Determination 2017/075

Regarding the code-compliance of decks to a house at 9 Adamson Road, Taipa

Figure 2: As-built deck to cladding junction

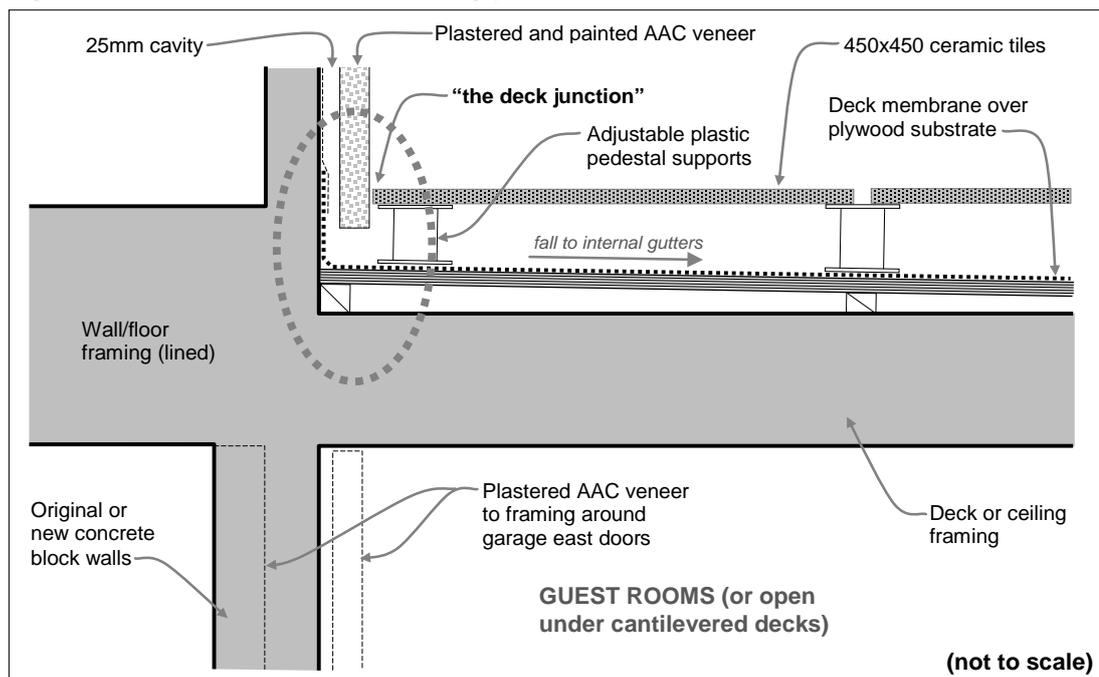
2.6.3 The deck to wall cladding junction as constructed is shown in Figure 2. Although the designer maintained that spacers provide a 5 to 7mm gap at the junction, the expert observed no gap on the east elevation and a small gap on the north elevation. At the glazed doors a 50 x 20mm aluminium angle is installed at the threshold, with the 20mm leg overlapping the edge of the deck tile.

- 2.8 Following a final inspection on 12 May 2017, the authority emailed the designer on 12 July 2017 stating:
- Further to a peer review of the above Building Consent, [the authority] requires a minimum 12mm gap between all deck tiles to wall cladding/door sills to the top and ground floors.

...asked for the deck tiles next to the building exterior cladding to be cut to provide a 12mm gap as per the building consent plans. To provide a 12mm space between deck tile and exterior building wall.

- 4.3.6 The expert concluded that, given normal maintenance:
The water proofing details of the cladding system itself are sufficiently robust, and the likelihood of ponding or retained water more than a film of water at the joint occurring at the junction of the tiles and the cladding is sufficiently low, that it can [be]

reasonably concluded that detail as constructed will perform adequately to the requirements of clauses and E2 and B2 of the NZBC despite the lack of a 12mm gap.

- 6.1 In accordance with section 188 of the Building Act 2004, I hereby determine that the deck junctions as constructed comply with Clause B2 and Clause E2 of the Building Code.

Figure 3: The relevant threshold detail from E2/AS1

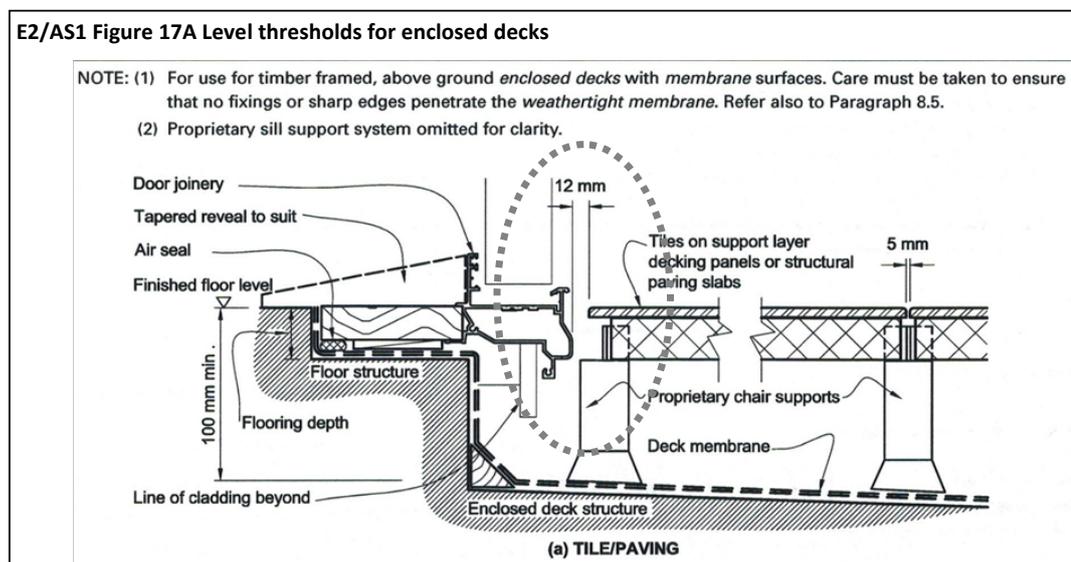
Raised removable surfaces of tiles, pavers or timber shall be provided over the underlying weathertight enclosed deck surface for cleaning and maintenance, as shown in Figure 17A. A minimum gap of 12 mm shall be provided [emphasis added] against the wall or balustrade cladding.

- 4.3.2 The expert noted that E2/AS1 provides one solution for deck junctions that incorporate materials ranging from absorbent to non-absorbent deck surfaces and from vulnerable to robust wall claddings.

- 4.3.3 The most vulnerable combination catered for by the Acceptable Solution would be an absorbent timber deck surface adjacent a vulnerable wall cladding such as fibre-cement sheets⁸ fixed directly to the framing, where there may be long periods where decking is saturated and the lack of a gap could allow water to transfer from the wet timber through the absorbent cladding and into the framing.
